MIL-F-50541A (AR)
AMENDMENT 4
7 December 1992
SUPERSEDING
AMENDMENT 3
09 February 1990

MILITARY SPECIFICATION

FUZE FOR FLECHETTE WARHEAD, WDU4A/A (LESS EXPULSION CHARGE)

Figure 1. Helicopter Vibration

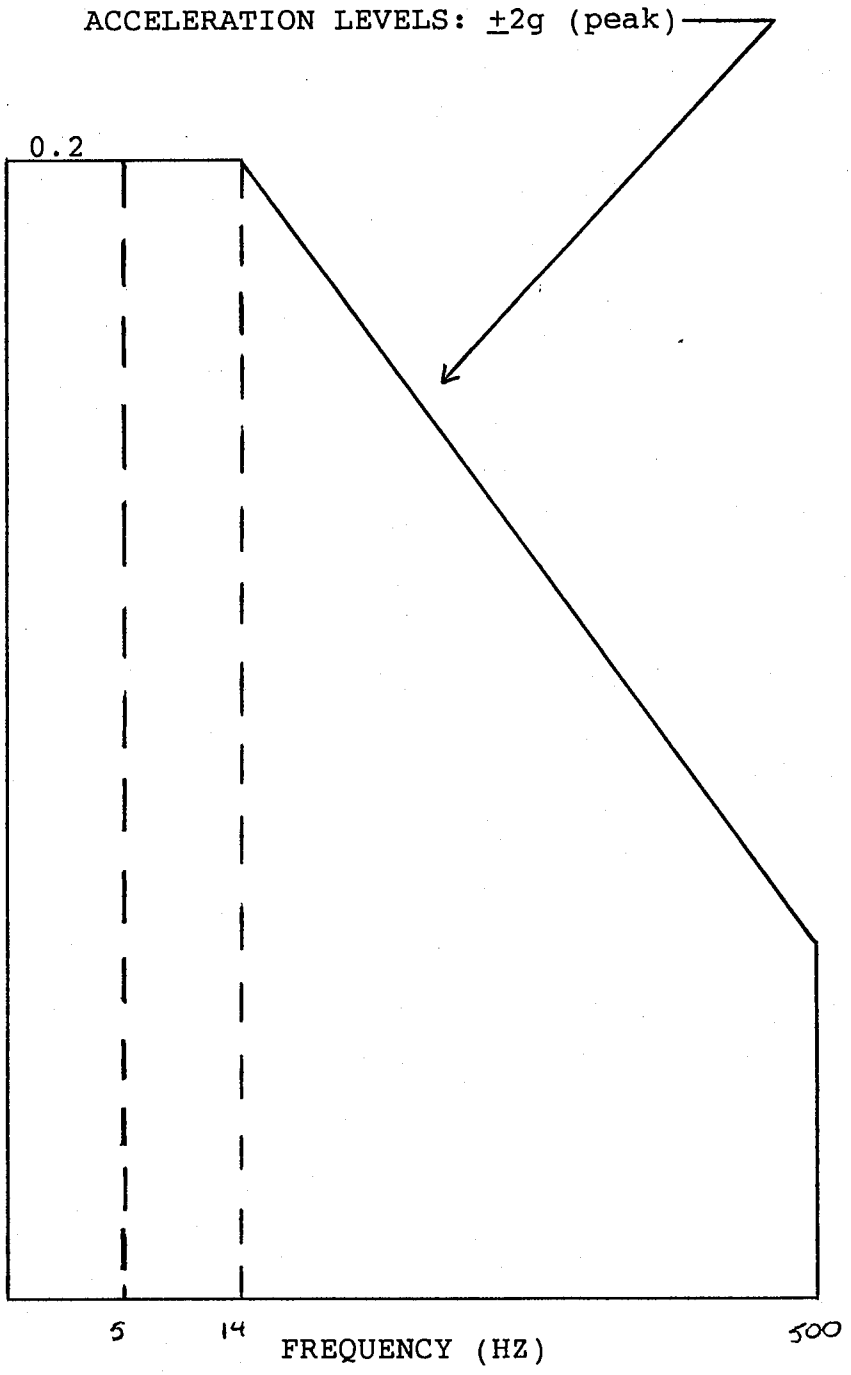
Appendix A: Delete in its entirety and substitute enclosed Figure 1.

One 15 minute sinusoidal sweep (5-500-5 HZ) shall be performed for each of three axes. No dwell time shall be spent on any one frequency. A search for resonance shall not be done.
